Safety Alert	
	Flight Design GmbH Sielminger Str. 51 D-70771 L.-Echterdingen Tel.: +49(0)7021 80460-0 Fax: +49(0)7021 80460-69 E-Mail: airworthiness@flightdesign.com	SA-LTUL-CTSW-04 Revision 00
	Date of Initial Publication: 16-Aug-2010 Publication Date of this Revision: 16-Aug-2010

SAFETY ALERT

Temporary Airspeed Limitation CTSW

SA-LTUL-CTSW-04

3.1 Airspeed Limitation

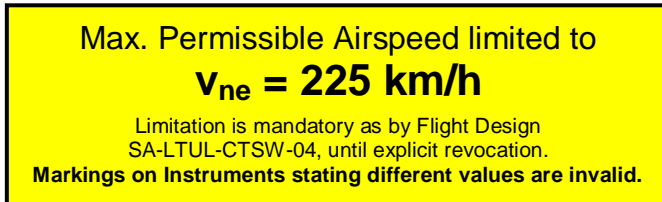
Until further information is available resulting from the analysis of the new ground vibration test, the never-exceed speed of the affected aircraft is reduced to $v_{ne} = 225$ km/h.

This new limitation must be displayed in the cockpit and in the aircraft operating relevant manuals.

Print the following placard in color.

Install placard to the instrument panel, in direct vicinity to the airspeed indicator. When the aircraft is indicated with an EFIS, install close to the EFIS in a location, where the pilot must notice it when operating the aircraft.
